Access Compliance Report Public Rights-of-Way (Curb Ramps)

Main Street: ANDORA_DR		Cross Street: MERCADO_AVE		Location:	NW
ADA ID: RPAT210921092948	Ramp Type: Type 4 - Parallel	Initial Pass/Fail: Fail	Overall Compliance: No	Severity Score:	16

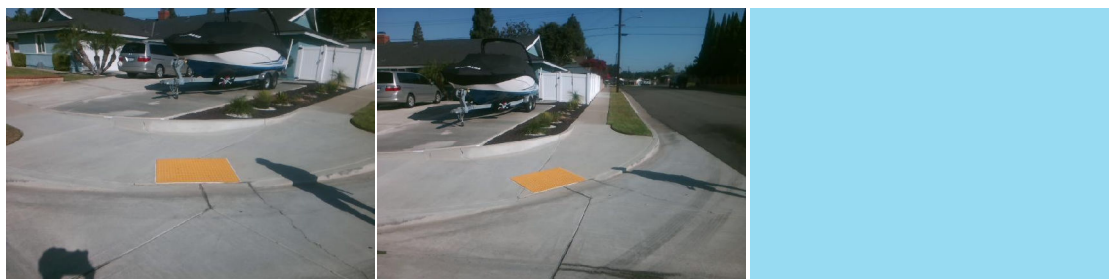
Compliance	Description	Data	Compliance	Description	Data
N/A	Ramp Length LT (in)	90	N/A	Ramp Length RT (in)	144
Yes	Ramp Width LT (in)	109	Yes	Ramp Width RT (in)	98
Yes	Ramp Run Slope LT (%)	6.4	No	Ramp Run Slope RT (%)	11.8
No	Ramp Cross Slope LT (%)	2.6	Yes	Ramp Cross Slope RT (%)	0.5
N/A	Landing Present	N/A	N/A	DWS Provided	N/A
N/A	Landing Length (in)	N/A	N/A	DWS Contrast	N/A
N/A	Landing Width (in)	N/A	N/A	DWS Length (in)	N/A
N/A	Landing Run Slope (%)	N/A	N/A	DWS Full Width	N/A
N/A	Landing Cross Slope (%)	N/A		DWS Offset Type	N/A
N/A	Landing Movement Obstructed?	N/A	N/A	DWS Offset Left (in)	N/A
	Landing Movement Type	N/A	N/A	DWS Offset Right (in)	N/A
N/A	Landing Shared	N/A			
N/A	Clear Space	Yes			
N/A	Clear Space To Crosswalk (in)	N/A			
N/A	Marked Crosswalk 1	No	N/A	Marked Crosswalk 2	No
	Crossing 1 Direction	S		Crossing 2 Direction	E
	Marked Crosswalk 1 Width (in)	N/A		Marked Crosswalk 2 Width (in)	N/A

Remove & Replace Curb Ramp With Two New Directional Ramps or Equivalent.
